Camden planning application ref. 2014/7227/IP - associated ref. 2014/4722/P

I first wish to address the **Design and Access Statement** which contains some patently false statements (*in italics*) and our responses emphasised in **bold**. These were originally refuted in my letter 20.10.2014

photo 1 no. 15 rear extension photo 2 shows that neighbouring balcony and terrace photo 3 this referred to as 'balcony'
(which were illegal) have been removed in application is clearly not so.

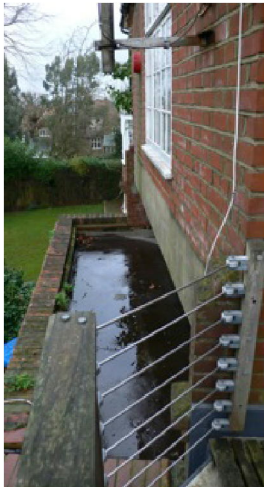
2.1 In fact an extension 2.6m deep front to back (see photo attachment 1) has already been built at 1st floor level in the order of 30 years back. This was presumably within the 10% of the original construction allowable. It was done in our absence and without our pre-knowledge.

2.2 p.5 of the DES shows 2 photos used to claim precedent for the proposed balcony. Neither of these were legally used as balcony and terrace and what might have been construed as safety barriers have now been removed (see photo attachment 2).

6.1 as responded to the earlier application, this is not and has never been a balcony, there is a drop of 157cm from the casement window to the surface of the small flat roof*, this is indicated in the side section A-A. *The dimension of this front to back is approx. 825cm, clearly this would not enable use as a balcony. There clearly could not be enabling access for this to be the case (see photo attachment 3)

photo 4 flashing to no.9

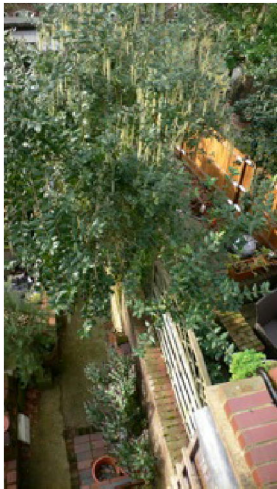
7.1 There are 3 'Garrya elliptica' trees of 5m plus within falling distance of proposed development. More importantly, their roots are dangerously close to the Party Fence Wall and the proposed ground floor extension to no.15 (see photo attachment 4)

these proposals: specifically, a reinforced concrete beam 49cm D x approx. 22cm W, spanning the whole of this rear facade, together with all of the brick work surrounding the existing casement window. This beam rests upon pad stones, the nearest of which is in the 9" Party Wall, sitting on the innermost brick. This leaves only the width of one brick to the outer, into which the Sarnafil membrane (up-stand flashing of our terrace) is installed. This is a specialist material and installation which would be expensive to restore if disturbed ((see photo attachment 5)

Of further note in this respect- at present, rainwater from the small flat roof of no.15 falls onto the steps to the garden, there is no soak-away and consequently the Party Wall is subjected to excessive damp (see photo attachment 6). There is no gully to the rear of this property, if the proposed ground floor extension were to be built, the only means of drainage from the roof would be a soak-away. However, building regs. require that 'a soak-away should not be within 5m of a building or 2.5m of a boundary'; given the garden size, possible compliance is questionable.
